**Subject:** Data Gaps Work Plan

**Subject:** Conditional Approval of Surface Geophysical Data Collection portion of Data Gaps Work Plan

Figures to Accompany  
*Conditional Approval of Surface Geophysical  
Data Collection portion of Data Gaps Work Plan*

**To:** EPA  
**Copy To:** File 80021  
**From:** J. Lambert, J. Brunelle  
**Subject:** Olin: Comprehensive Data Gaps Work Plan Review Comments  
**Date:** 8/22/19

Figure 7

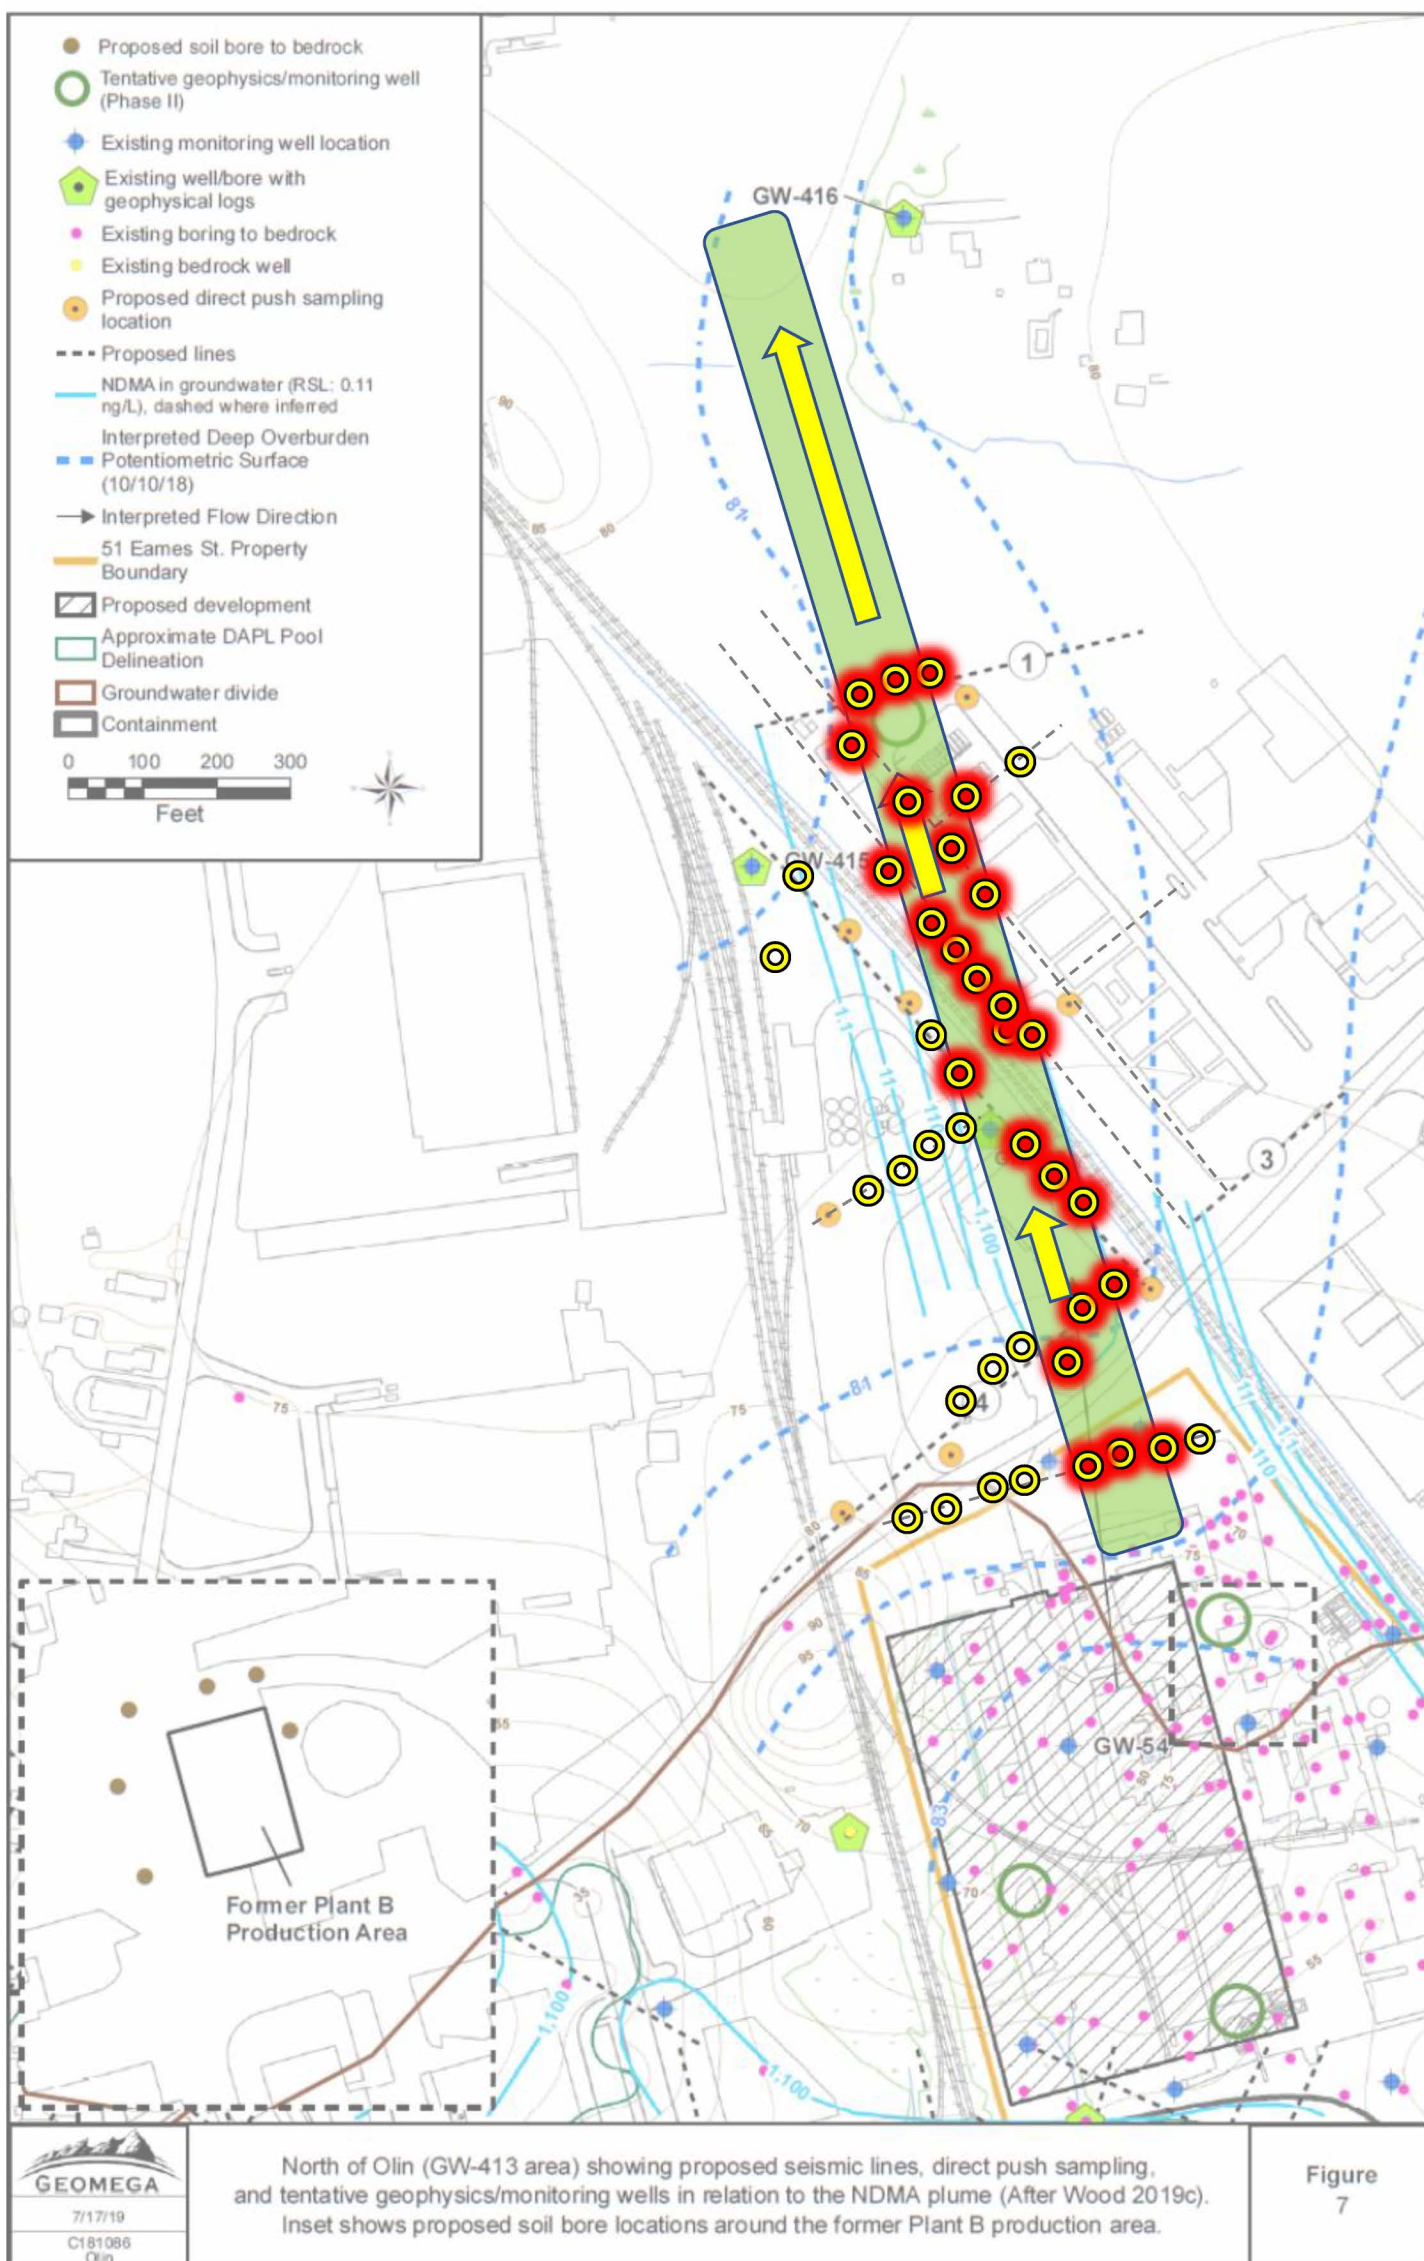
Geophysical Survey Line	Status	GW Profiling Transects/Comment
1	Concur/Modify	GW profiling transect should be adjusted to follow seismic line 1. At least 2 new GeoProbe locations needed to resolve plume core; (see Figure).
2	Concur/Modify	GW profiling transect follows seismic line 2 alignment; at least 5 additional GeoProbe locations needed to NNW and SSE of GW-413 along seismic line 2 to resolve plume core (see Figure).
3	Concur	No confirmatory GeoProbe locations are planned, but this should be reevaluated following completion of seismic data

4	Concur	At least 3 additional GeoProbe points needed along transect which generally follows seismic line 4 transects; new points focused to delineate core location (see figure)
5	New	New 500-ft Seismic reflection line proposed south of Eames street; New GeoProbe transect of 8 locations with a lateral spacing of ~ 50 ft. (see figure).
6	New	New 300-ft Seismic reflection line proposed SW of GW-413 to define western edge of plume core; see Figure for proposed Geoprobe locations.
7A	New	New 1000-ft NW-SE oriented seismic reflection line proposed NW of RR tracks; GW profiling transect follows seismic alignment; at least 4 new GeoProbe points needed; see Figure.
7B	New	(Alternate to 7A); New 1000-ft NW-SE oriented seismic reflection line proposed NE of RR tracks in roadway between warehouses; GW profiling transect follows seismic alignment; at least 2 new GeoProbe points needed to augment existing transect in plume core region; see Figure.

8	New	New 200+-ft SW-NE oriented seismic reflection line proposed to define eastern plume core boundary; at least 1 new GeoProbe point needed to augment existing transect in plume core region; see Figure.
9	New	New 200+-ft SW-NE oriented seismic reflection line proposed to define eastern plume core boundary in region ~ 300 ft north of transect 8; at least 1 new GeoProbe point needed to augment existing transect in plume core region; see Figure.

Figure 8

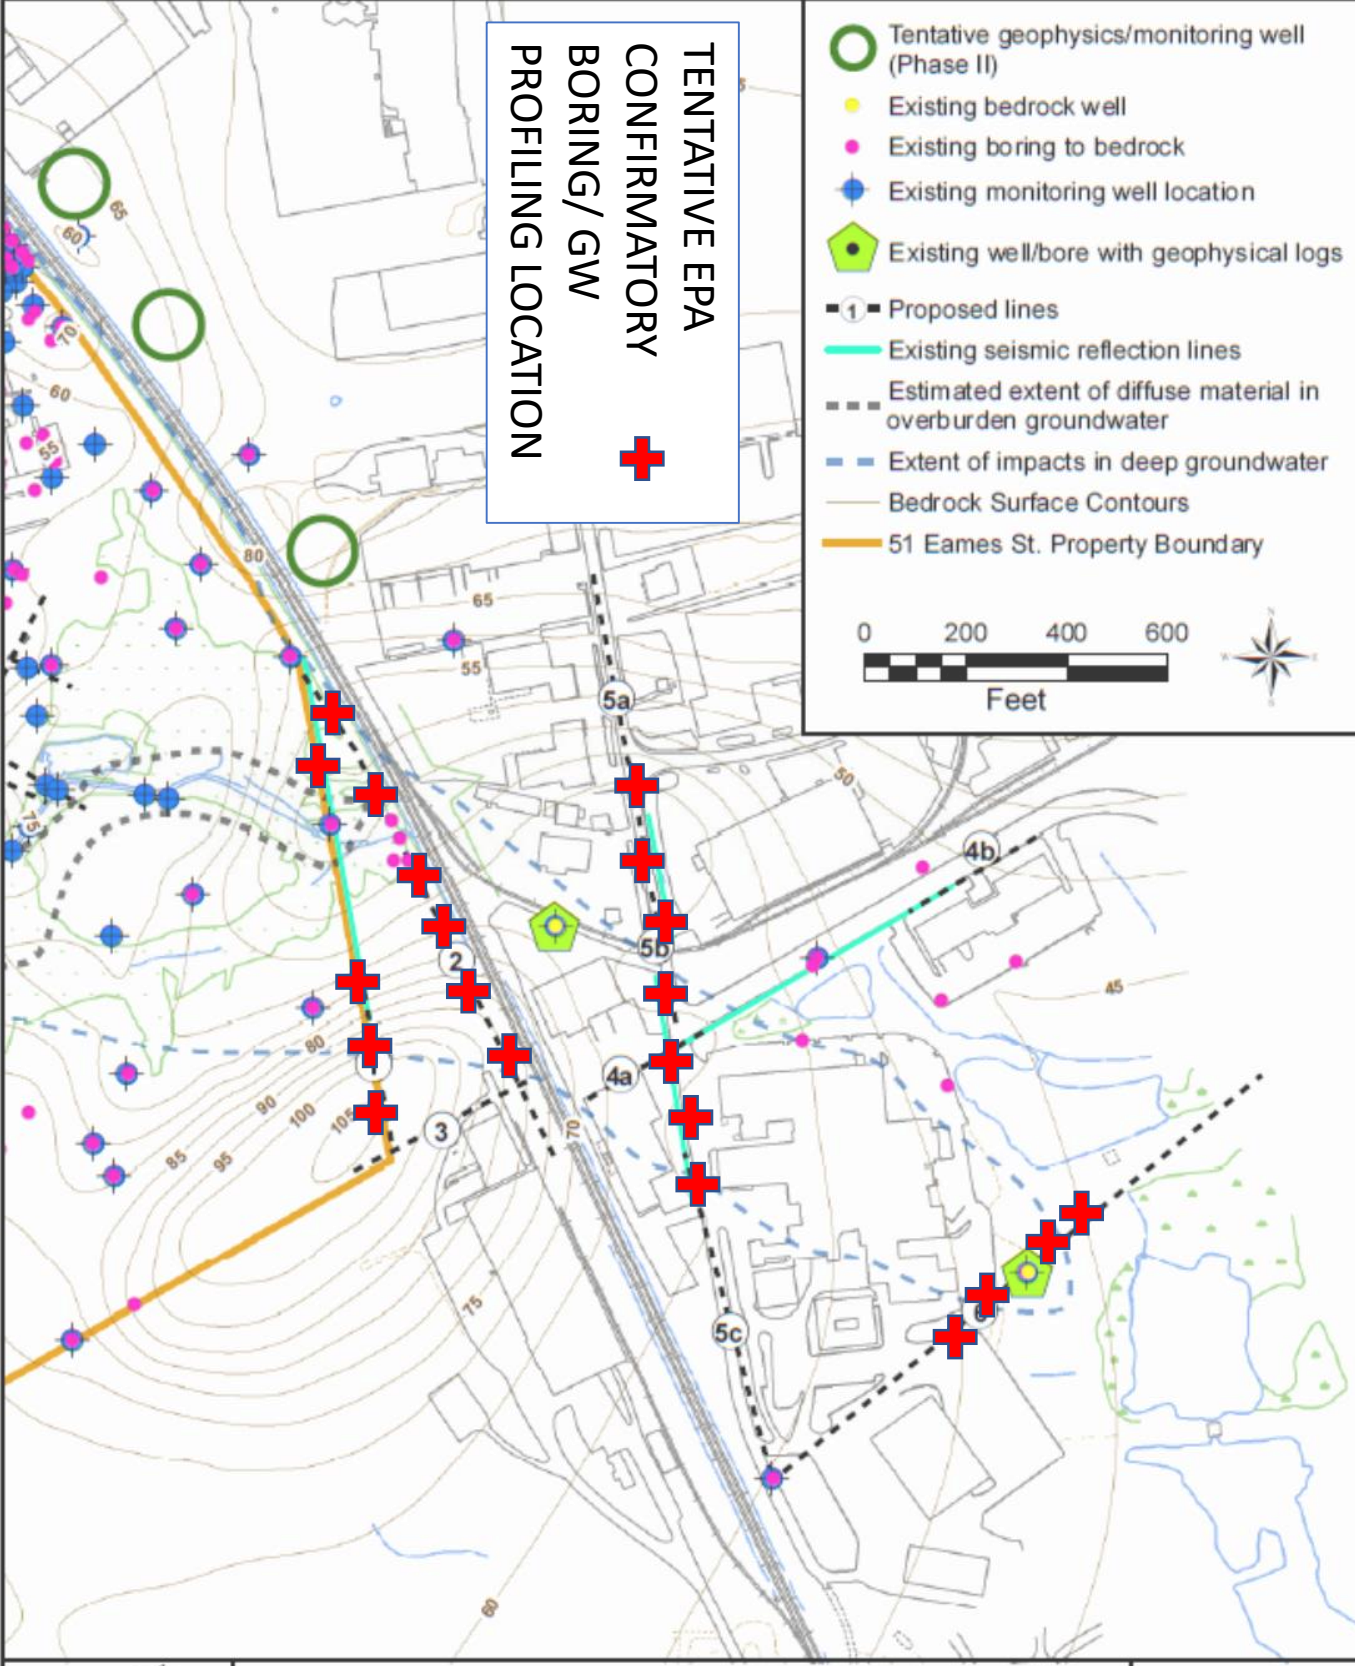
15. *East of Olin*; EPA concurs with the Olin's investigation plan for the areas East of Olin. We also concur with the proposal to defer identification of the number and location of confirmatory borings and monitoring wells until after the seismic data is in-hand for review. We have tentatively identified 21 provisional locations for confirmatory borings/vertical profiling of groundwater on the attached figure.
